**WORK ITEM 3. UPGRADE IT CLOSETS:**

DEPARTMENT OF VETERAN AFFAIRS VETERANS HEALTH ADMINISTRATION			
DENTAL, STAIRWAY, IT CLOSETS PROJECT			
DATE: OCTOBER 2014	SIZE: FSDM NO.	SHEET TITLE: LOCATION PLAN	REV
SCALE: NO SCALE		SHEET 2 OF 3

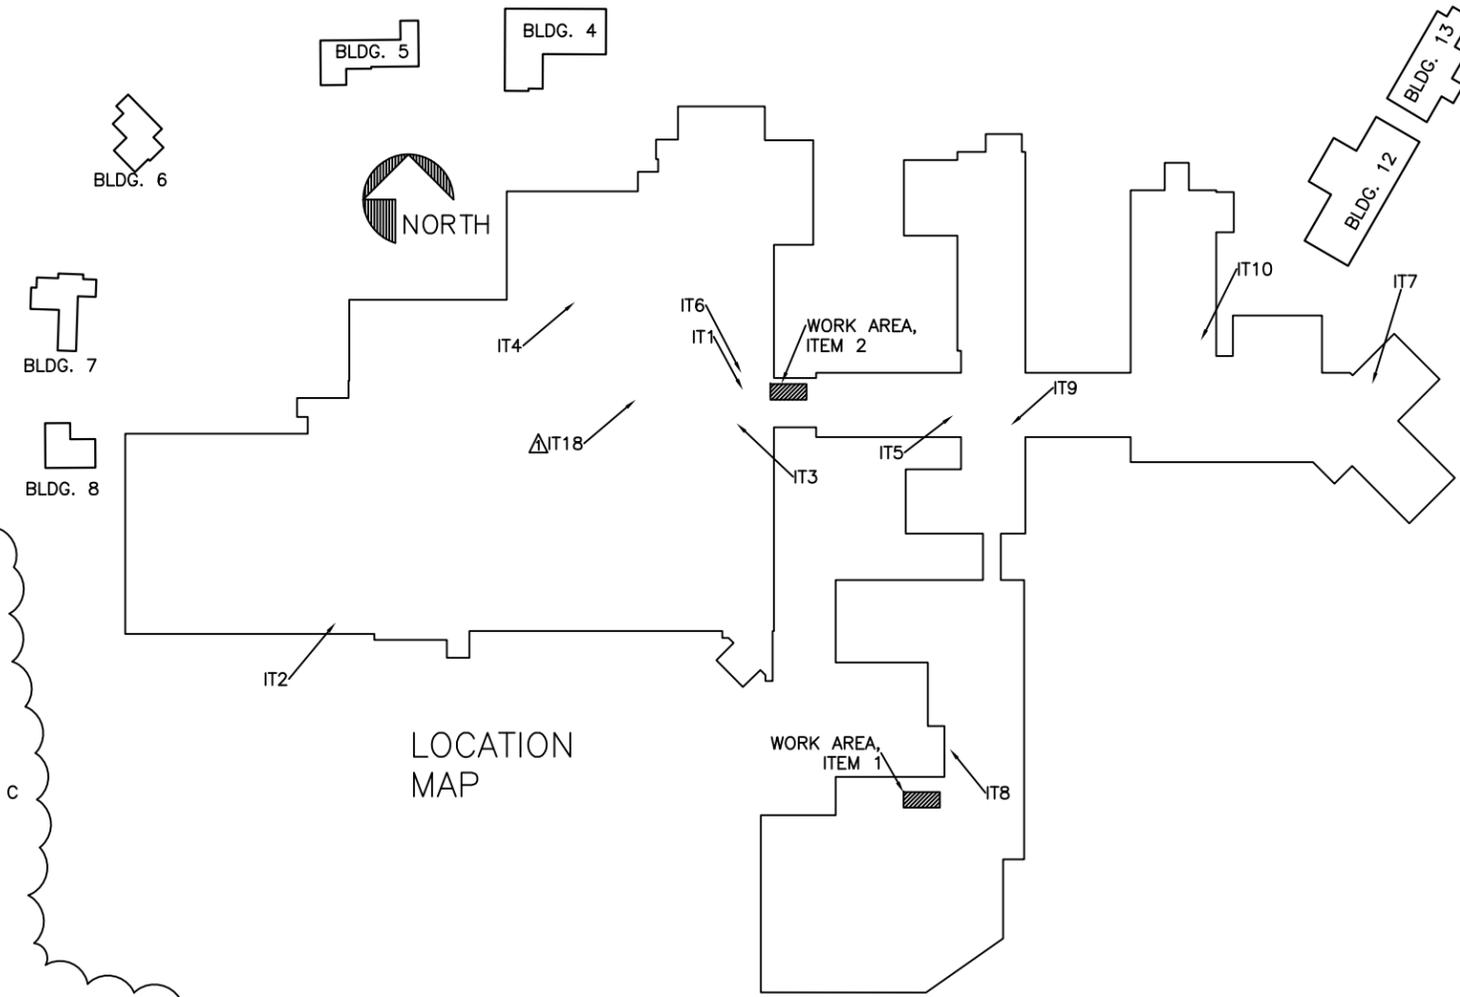
REVISIONS				
ZONE	REV	DESCRIPTION	DATE	APPROVED
	1	Revised work in IT Closets to show number of receptacles required. Added IT18: Room B2-152.	11/05/14	SR

IT1: Room BL-70, Basement: A(2), B, C  
 IT2: Room A1-26, 1st Floor: A(2)  
 IT3: Room B1-103, 1st Floor: B, C  
 IT4: Room B1-112, 1st Floor: B, C  
 IT4: Room C1-41, 1st Floor: A(1), B, C  
 IT5: Room B2-93, 2nd Floor: A(2), C  
 IT6: Room C2-15, 2nd Floor: A(2)  
 IT7: Room C2-119, 2nd Floor: A(2), C  
 IT8: Room D2-36, 2nd Floor: A(2)  
 IT9: Room C3-61, 3rd Floor: B, C  
 IT10: Room C3-73B, 3rd Floor: A(1), B, C  
 IT11: Building 4: A(1)  
 IT12: Building 5: A(1)  
 IT13: Building 6: A(1)  
 IT14: Building 7: A(1)  
 IT15: Building 8: A(1)  
 IT16: Building 12: A(1)  
 IT17: Building 13: A(1)  
 IT18: Room B2-152, 2nd Floor: A(2), C

A - Install L5-30R Receptacle, 10 AWG Conductor & Conduit from Electrical Room to IT Closet and New 30 Amp Breaker in Electrical Panel. Number in parenthesis represents number of receptacles required for that room.  
 B - HVAC  
 C - Provide and install 24" x 5" security louver in existing door.
